December 15, 2011

RE: Clarifications and Answers to Contractors Questions
 Harold Court East Regional Services Center Improvements CIP Number: 5700.012

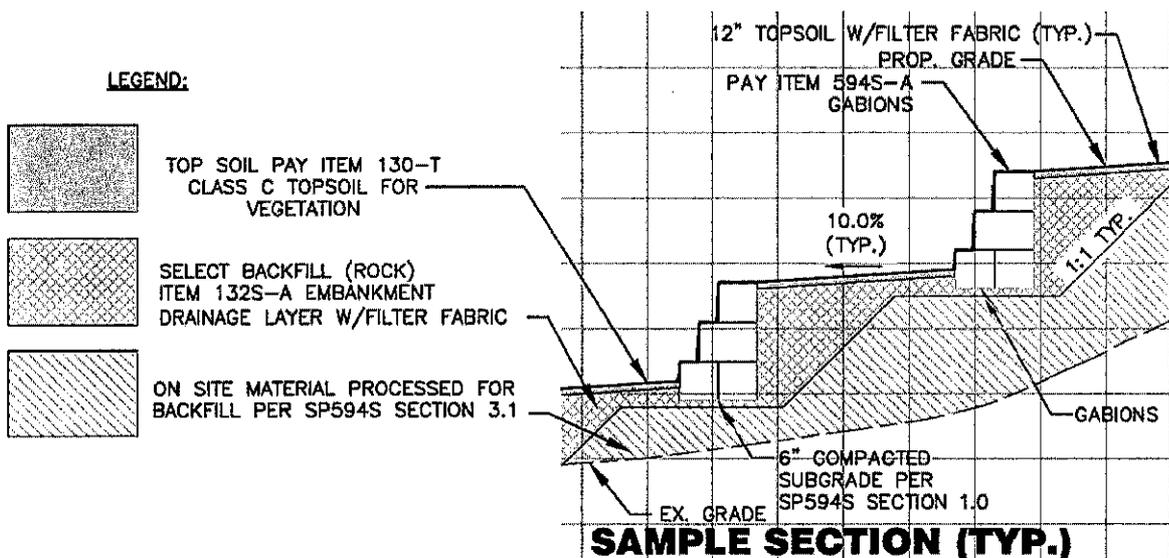
2. The Embankment and Excavation unit quantities on the bid form are they to bring the site to the benched sloped condition before the installation of the gabions? Do these quantities include the select fill shown on the draws as embankment even if the cross section shows the existing grade to finish face of wall to be in a cut section? My takeoff shows there is more select fill which is noted on drawing to be embankment typ. Then the total quantity for embankment on the bid form and this does not include the quantity for the embankment labeled as In-situ material on section views. Likewise dose the excavation quantity on the bid form include the excavation for the gabions and the select fill (noted embankment typ.) to get it to the sloped benched condition prior to installing the gabions and select fill? Should or could there be a bid item for the select fill and will you adjust the quantities for the excavation behind the face of gabion wall to the sloped construction line for the select fill?

The inserted image provides labels to correlate the bid items to the placement of the materials behind the gabion walls. The relocating of the on-site in-situ materials is considered subsidiary to the installation of the gabion walls per Standard Specification 594S, Section 594S.6 Payment:

"Excavation and all subgrade preparation required for shaping the foundation for the wire containers shall be included in the unit price for "Gabions and Revet Mattresses".

For informational purposes the AutoCAD earthwork analysis indicates the required amount on-site material to be processed and relocated on site for the backfill shown behind the drainage layer in the inserted image, in accordance with Special Specification SP594S Section 3.1 is approximately 41,000 cubic yards. Additionally the Section 300U pay item 111S-A "Excavation" is the amount of this on-site material that must be hauled off-site and disposed of properly.
